**Planning Application ref: R10/2303
(Proposed windfarm at Cestersover Farm, CV23 0QP)**

Objections of Churchover Parish Council

July 2011

Figure 1
Photomontage Locations

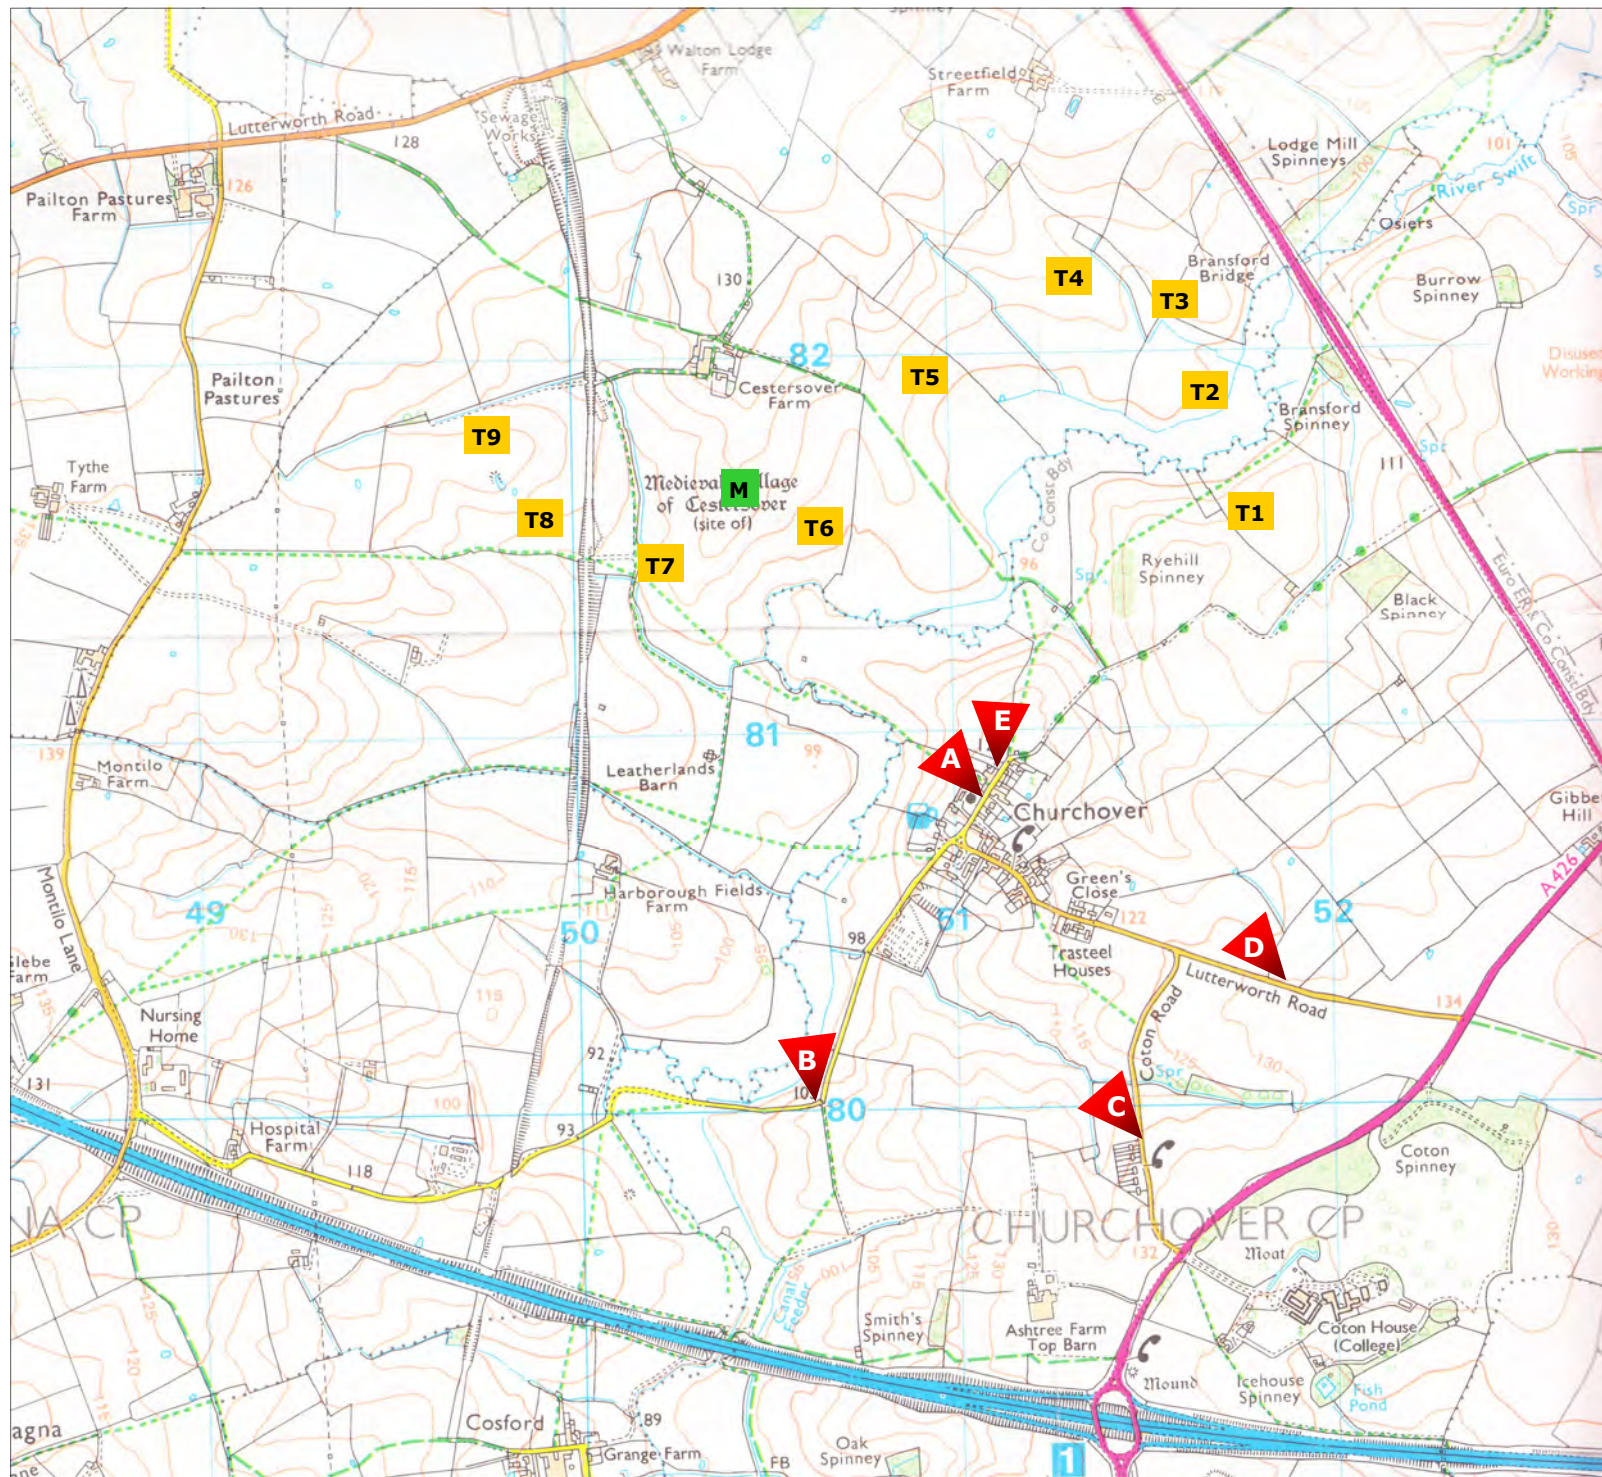
- 2.24 Figure 1A illustrates more accurately than does SSE the view from Churchover churchyard; it is taken from SSE's viewpoint 1 but using a 55mm lens and not a very wide angle lens. It proves that if a more typical viewpoint is selected, three turbines 7, 8 and 9 are not hidden behind trees but are in fact very prominent in the view – and would be still more dominant if the viewpoint had been the churchyard extension. Quite simply, SSE's assessment gives no clue about the visual impact experienced within Churchover; Figure 1A gives a much more accurate representation, which could easily have been made still more prominent by choosing a viewpoint in the churchyard extension.

- 2.25 Figure 1E depicts a recent 70th birthday party in the garden of Field View, and is a wide-angle (28mm) photograph. It illustrates very well how prominent and unavoidable will be the presence of three turbines. Other garden views will be worse, but this is typical.

- 4.17 Figures 1B, 1C and 1D⁵⁵, appended, represent three key local views of the village as experienced by residents every day, while walking and driving. They typify the village landscape setting. Figure 1B is roughly equivalent to SSE's additional viewpoint A, but CPC's is again with a 55mm lens to represent the human eye, and not SSE's wide-angle view. Either photomontage illustrates the considerable damage to the view, especially when focused upon Cestersover Farm

- 4.18 CPC's Figure 1C roughly equates to SSE's additional viewpoint D. Once again, it can be seen how SSE's wide-angle approach trivialises the impact, but even their view demonstrably diminishes and subordinates one of the best views of the church and village in its context.

- 4.19 CPC's Figure 1D is a view from the layby on Lutterworth Road, a view of importance second only to view 1C, and is not replicated by an SSE view. That is not surprising. The three turbines 7, 8 and 9 totally dominate the church spire and, when rotating, would be impossible to ignore.
